Access Compliance Report

Public Rights-of-Way

(Curb Ramps)

Intersection ID: 3350	Main Street: FALLS_RIDGE_LN	Cross Street: CANIPE_DR	Location:	S
ADA ID: A3E9246E23EF	Ramp Type: Perp	Initial Pass/Fail: Fail	Overall Compliance: No	Severity Score: 8.75
Codes/Mitigation Info/Possible Solution		Field Measurements/Component Compliance

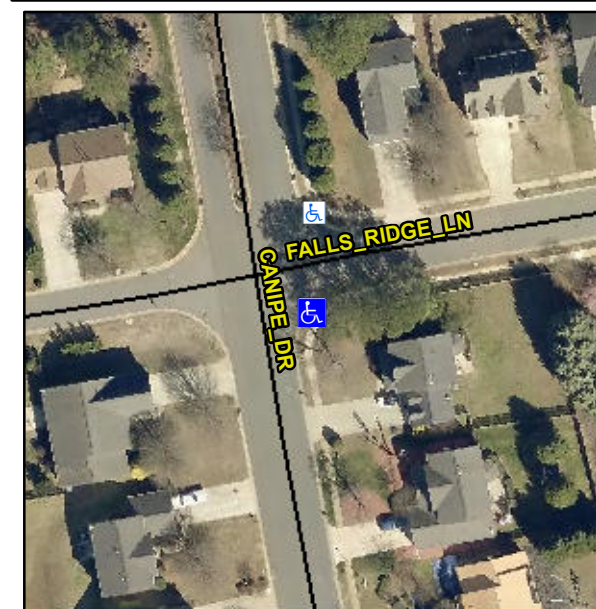
Not Found, R304.5.1

Compliance	Description	Data	Compliance	Description	Data
N/A	Ramp Length (in)	52.5	Yes	Ramp Slope (%)	5.4
No	Ramp Width (in)	47.0	Yes	Ramp XSlope (%)	1.5
N/A	Flare Type LT	N/A	N/A	Flare Type RT	N/A
N/A	Flare Slope LT (%)	N/A	N/A	Flare Slope RT (%)	N/A
N/A	Flare Traversable LT?	N/A	N/A	Flare Traversable RT?	N/A
N/A	Landing Length (in)	N/A	N/A	DWS Provided?	N/A
N/A	Landing Width (in)	N/A	N/A	DWS Contrast?	N/A
N/A	Landing Slope (%)	N/A	N/A	DWS Length (in)	N/A
N/A	Landing X Slope (%)	N/A	N/A	DWS Full Width?	N/A
N/A	Landing Curb? (Y/N)	N/A	N/A	DWS Offset (in)	N/A
N/A	Shared Landing?	N/A			
N/A	Gutter Ponding?	N/A	N/A	Gutter Slope (%)	N/A
N/A	Gutter Lip Ht (in)	N/A	N/A	Gutter X Slope (%)	N/A
N/A	Painted X Walk1?	No	N/A	Painted X Walk2?	N/A
	X Walk 1 Direction	To N		X Walk 2 Direction	N/A
N/A	X Walk 1 Width (in)	N/A	N/A	X Walk 2 Width (in)	N/A
	X Walk 1 Slope (%)	5.2		X Walk 2 Slope (%)	N/A
	X Walk 1 X Slope (%)	5.2		X Walk 2 X Slope (%)	N/A

Remove & Replace Entire Ramp.
